**BIG SPRING
RECHARGE AREA**

**SOLE SOURCE
AQUIFER PETITION**

ADDENDUM

Re: Big Spring Recharge Area
Sole Source Aquifer Petition
Response to EPA Comments

Figure 1
 RELATIONSHIP OF
 SCENIC RIVERWAYS TO
 PROJECT REVIEW AREA

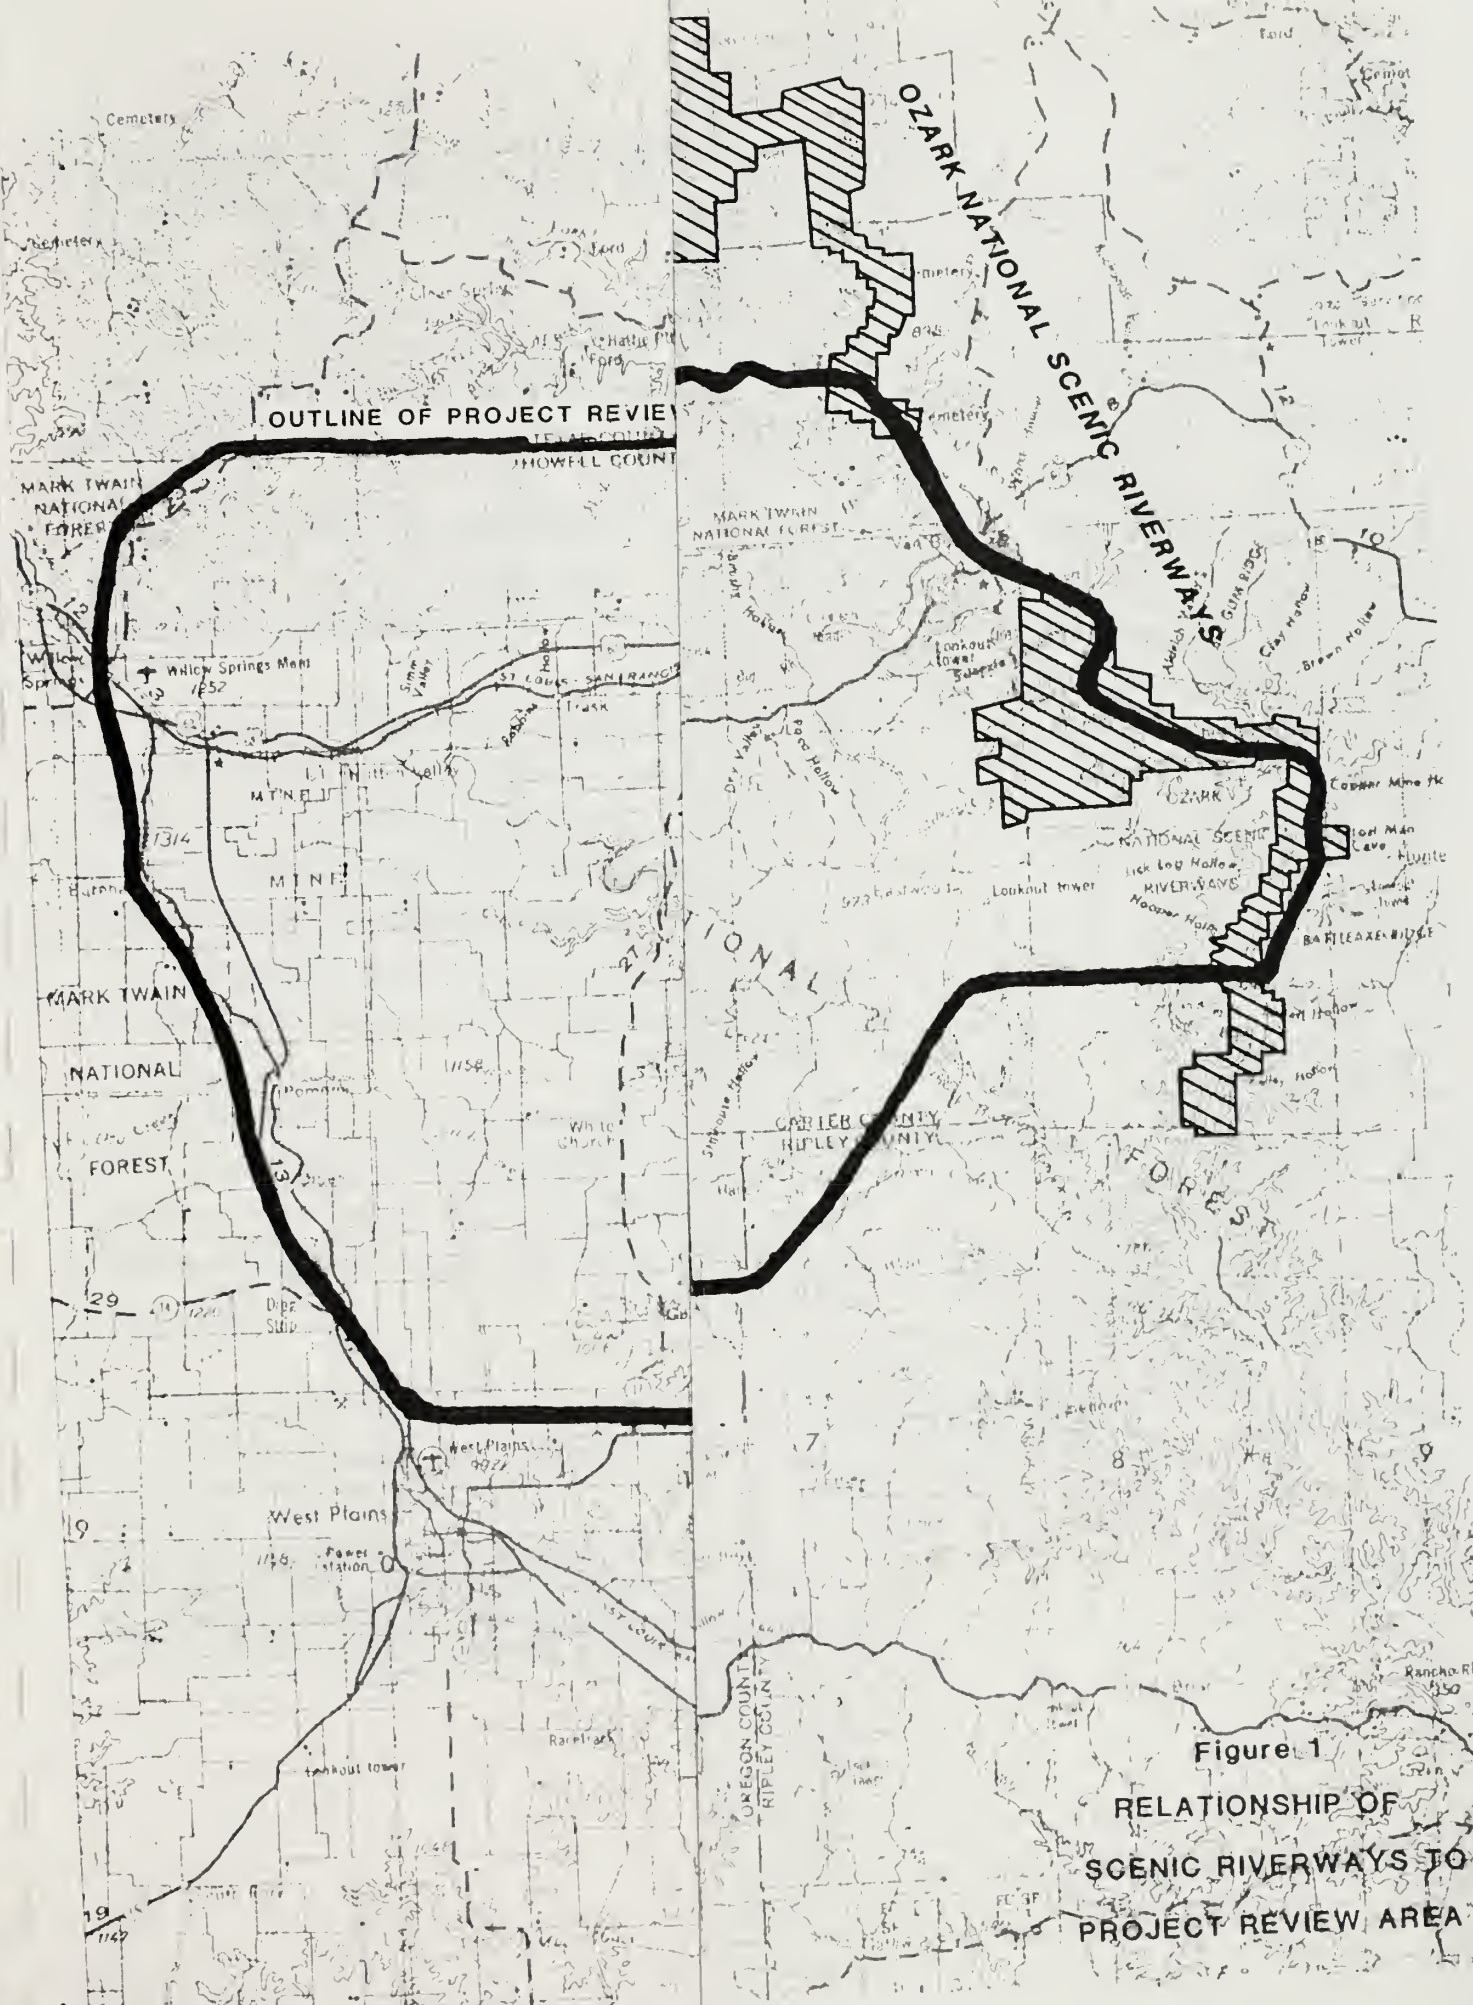
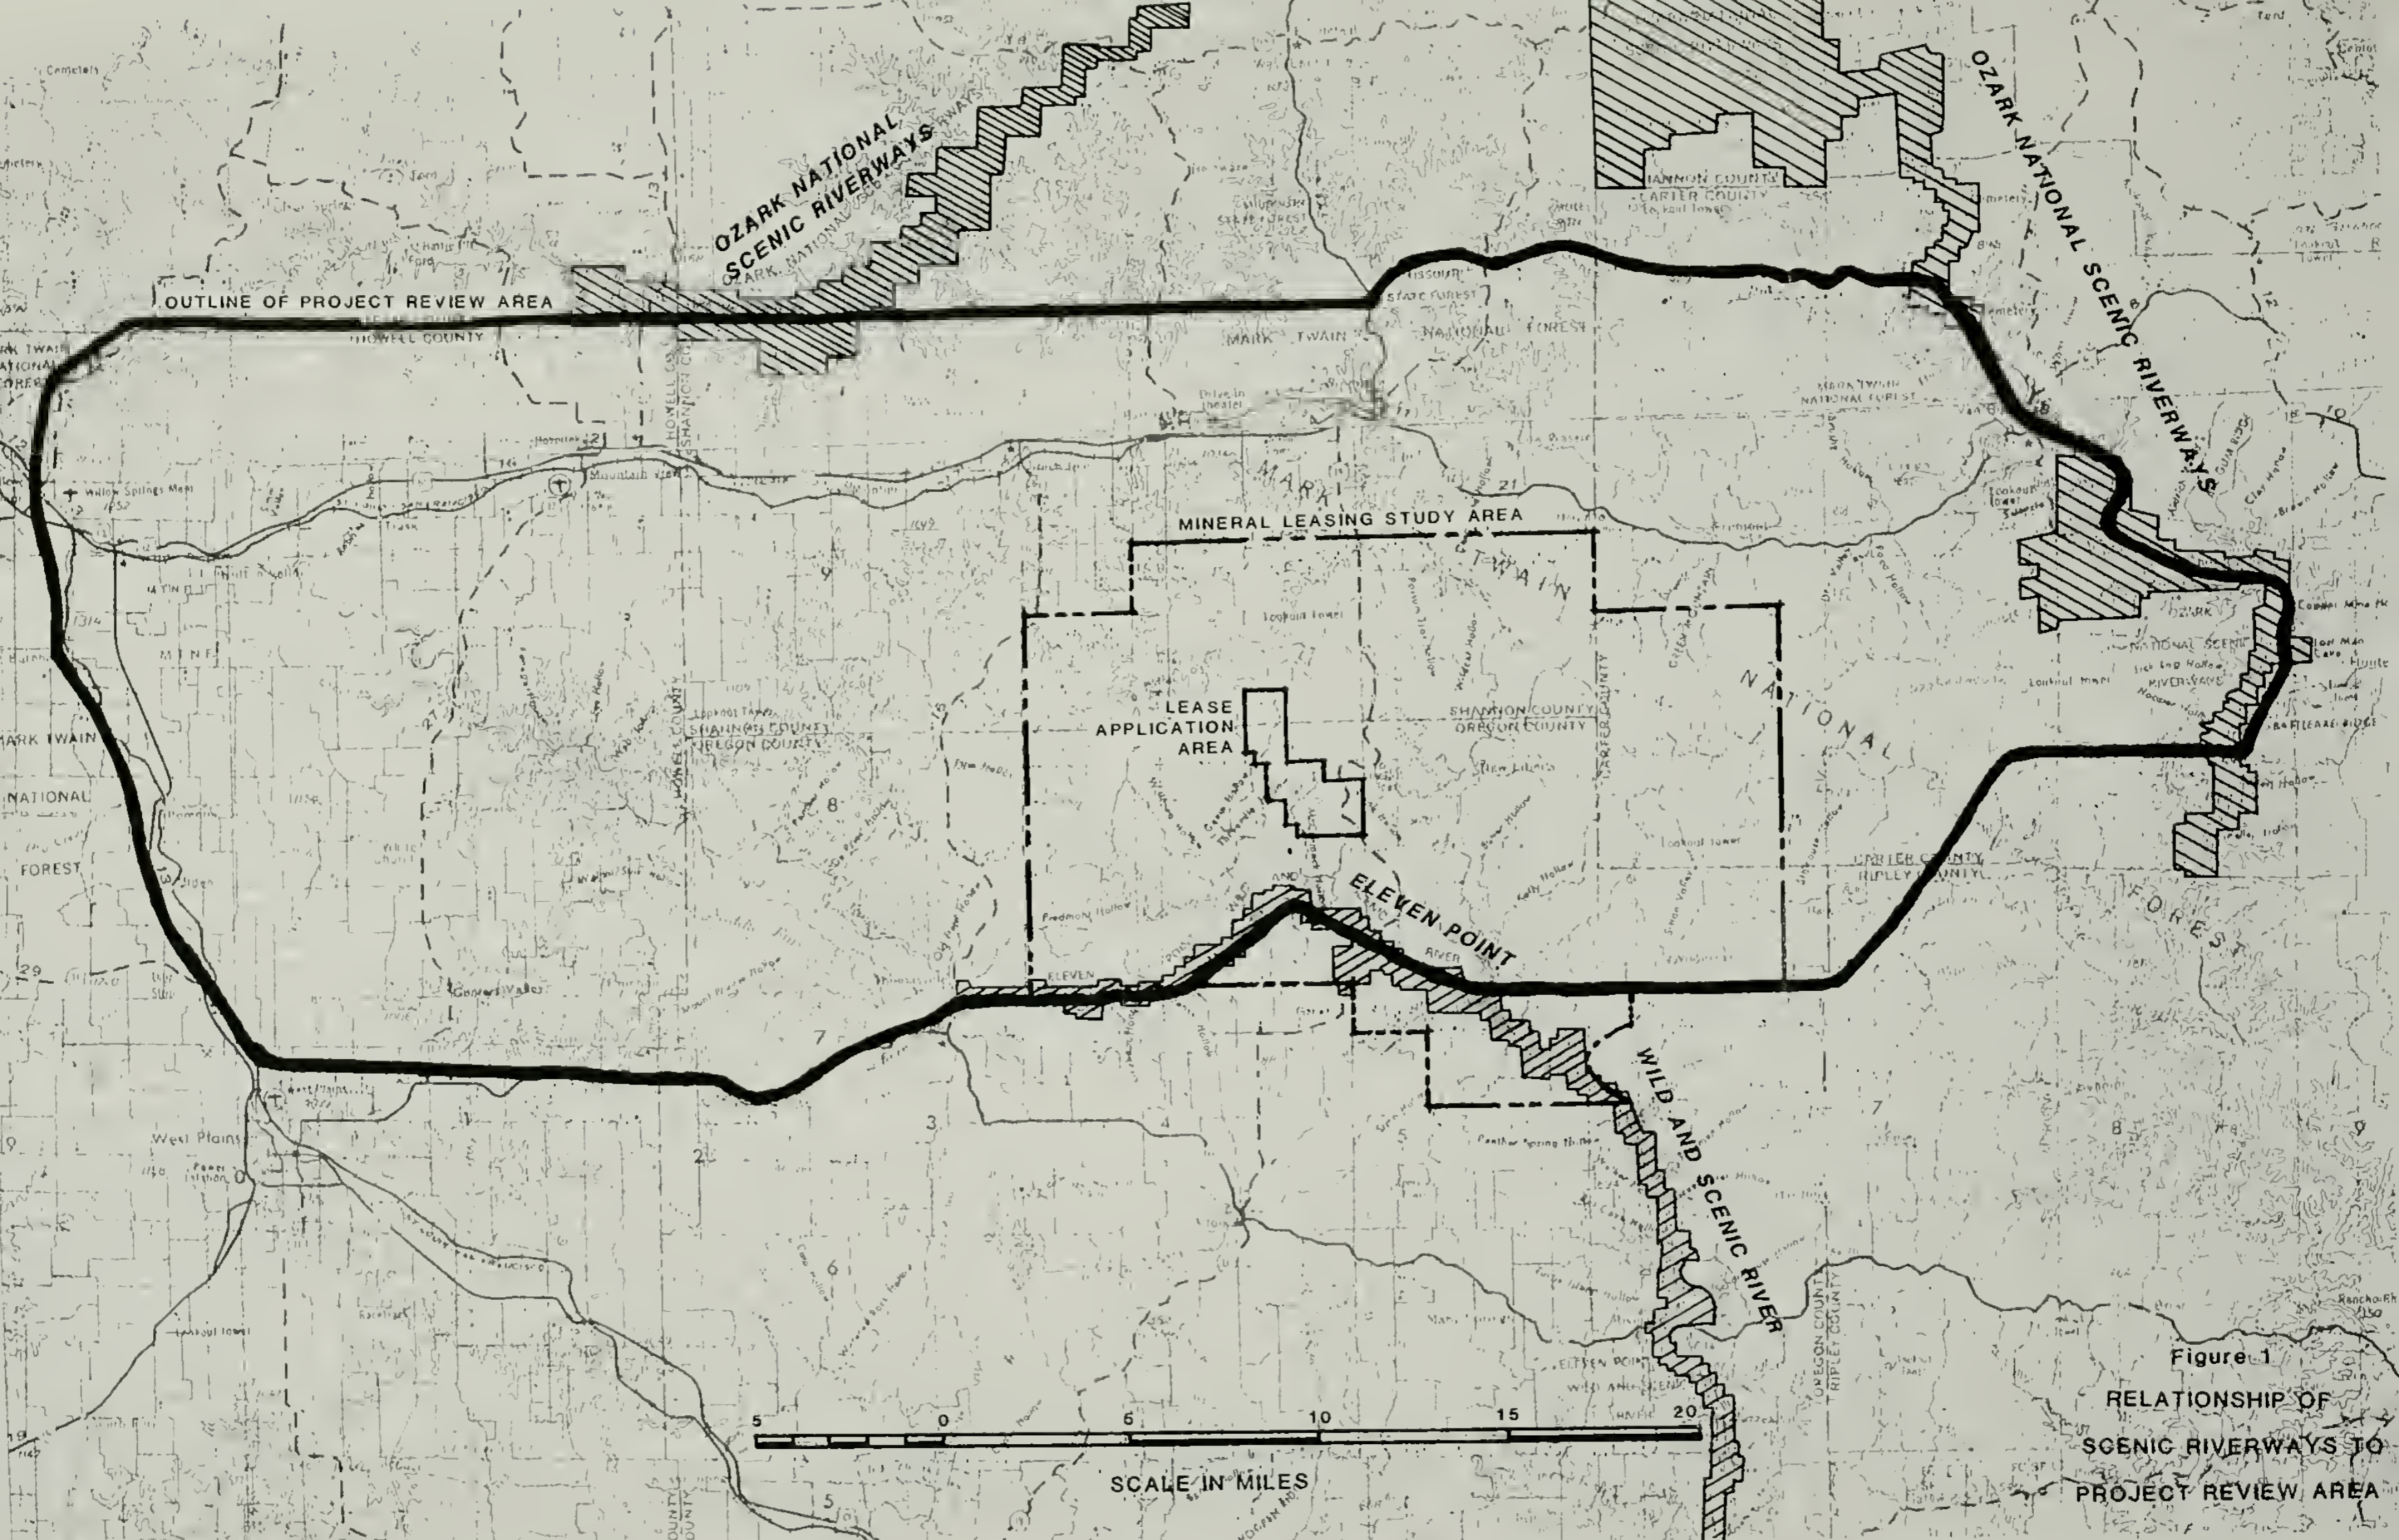
Comment No. 1: *A map indicating the boundaries of the Ozark National Scenic Riverways in relation to the petitioned SSA boundaries should be included.*

Comment No. 4: *Please indicate the scale for the map diagrams.*

Figure 1 of this Addendum displays the boundaries of both the Ozark National Scenic Riverways and the Eleven Point Wild and Scenic River and their relationship to the Project Review Area.

The scale of all maps in the initial petition and in this addendum is 1:250,000. The scales were inadvertently omitted from the maps in the petition dated October, 1989. A graphic scale drafted on Figure 1 of this addendum is applicable to all the maps in the original petition document.
